LIPA Generation Planning Review

Caithness Long Island II, and
E.F. Barrett and Port Jefferson Repowerings

April 6, 2017

Figure 2: New York ISO Zone K Non-Coincident Peak (after DSM reductions) vs. LIPA 2010 ERP

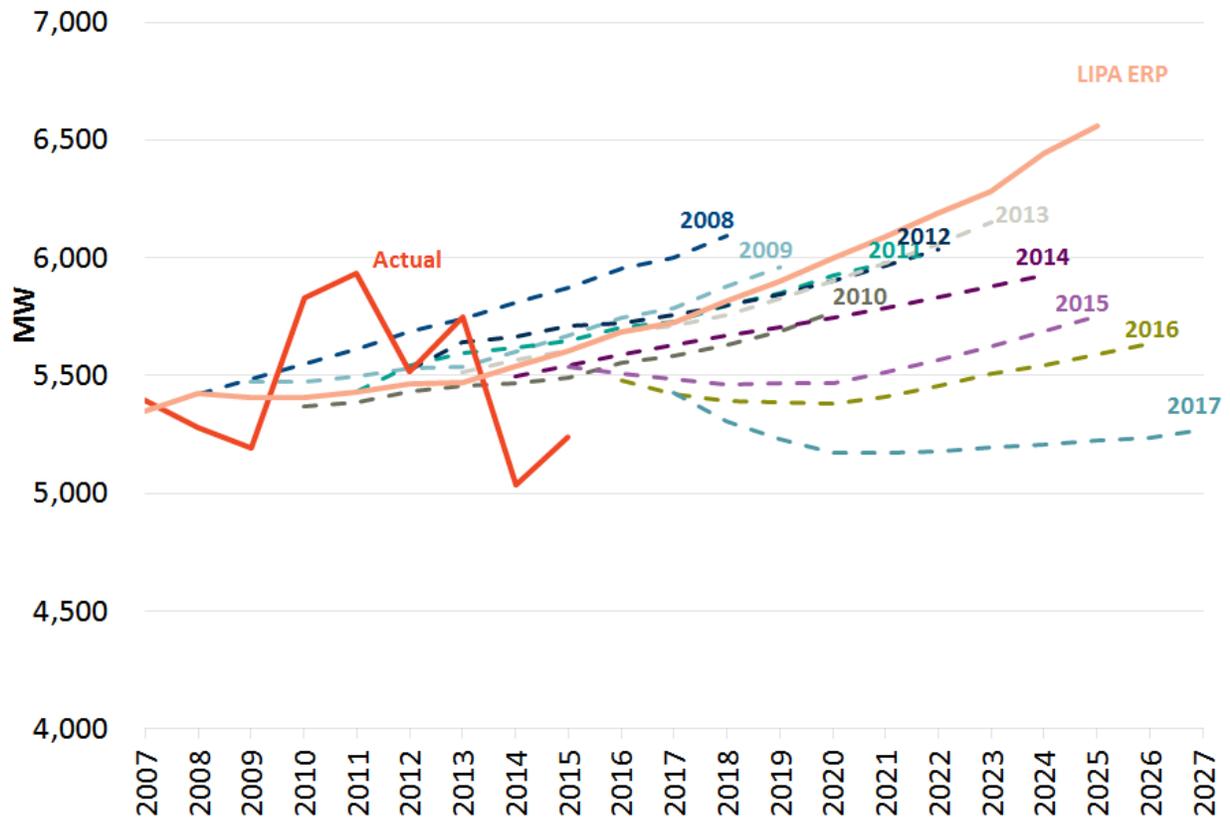
Perhaps most significantly, for reasons both planned (e.g., energy efficiency programs) and unplanned (the Great Recession), as Figure 2 below shows, the Zone K load forecast has come down dramatically over the past decade, causing the risk of LI becoming capacity-short to be reduced significantly for years to come, regardless of the reliability metric applied. The curves in this figure are the ten-year peak load forecasts for the LI zone that have been used annually by NYISO and LIPA for resource planning purposes since 2008. The line labeled "ERP" is the peak load forecast underlying the need assessment that resulted in the 2010 RFP in which CLI-II participated. Not shown on this graph is the projected capacity LIPA was expecting to then have on hand in those future years; this amount was about 200 MW in 2020 below the amount needed to satisfy LIPA's 80% CI reserve requirements. From 2020-2030, load was expected to grow by another 750 MW or so, hence necessitating new capacity.

Figure 2 also shows that by 2014, the ten year outlook was well below the 2008 ERP forecast. All these changes in NYISO, LCR variability, plant siting, and load expectations by 2014 led PSLI to recommend using the NYISO reliability criteria.

Figure 3: New York ISO Zone K Total Energy Forecast (including reductions from DSM) vs. Outlook in LIPA 2010 ERP

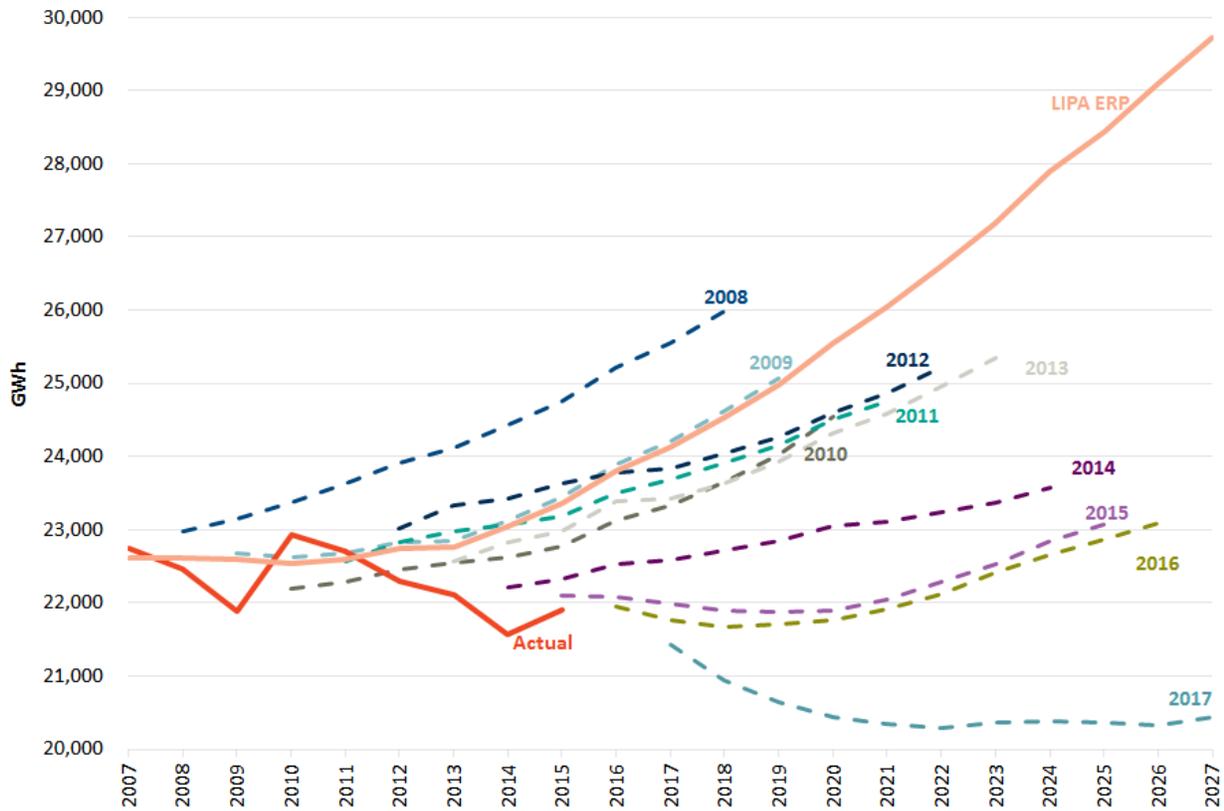
As Figure 2 illustrated, by 2014 it was becoming more apparent that new capacity in Zone K was unlikely to be needed as early as had been foreseen at the time of the ERP and the issuance of the RFP. In addition to the decline in recent past realized load and expected future load growth, a precipitous decline in natural gas prices resulted in lower electric power prices throughout all of NY and adversely affected the economics of new efficient baseload generation technology.

Figure 4: New York’s Natural Gas Prices vs. Energy Prices

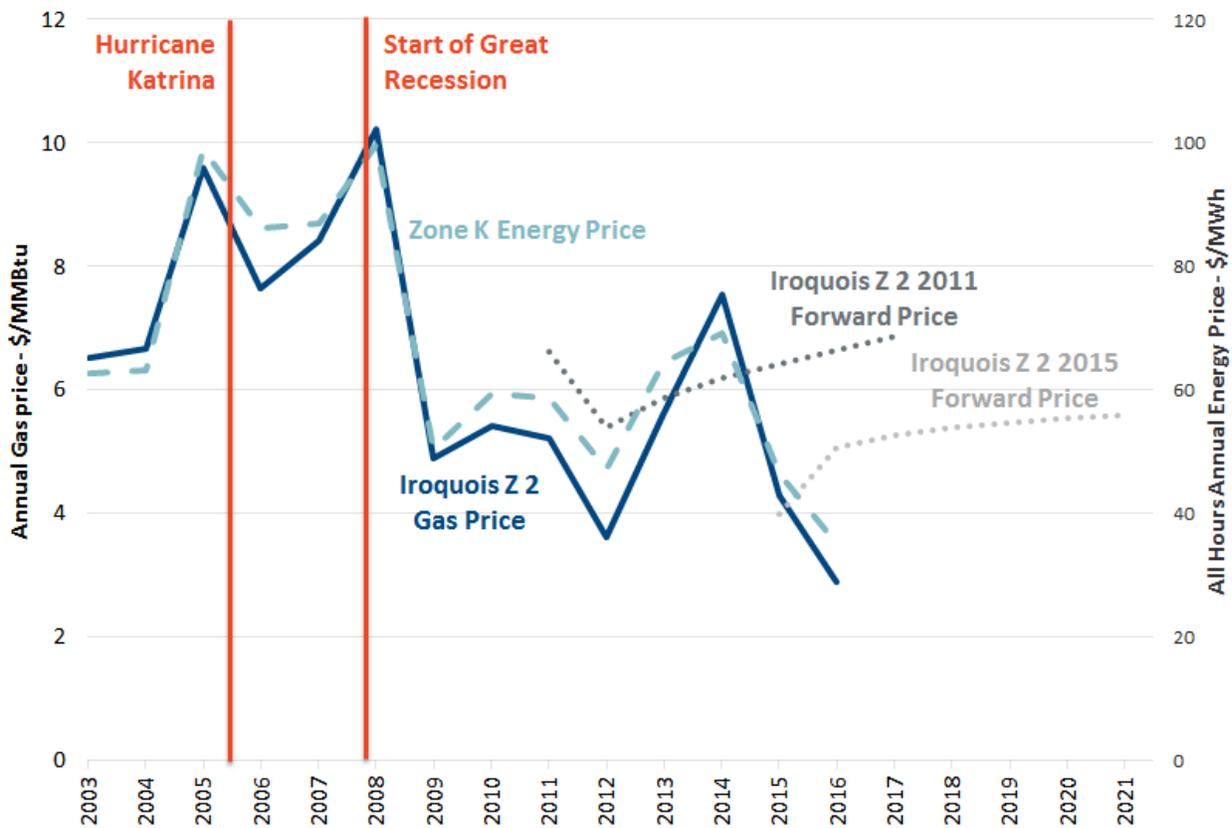
evident on the above chart by virtue of how closely the Zone K energy (spot electricity) price follows the time pattern of gas prices delivered to LI on the Iroquois Z2 location. As gas prices fall, market prices for wholesale electric energy also tend to fall, reducing the value of savings that can be obtained from new plants even if they are more efficient than existing plants.
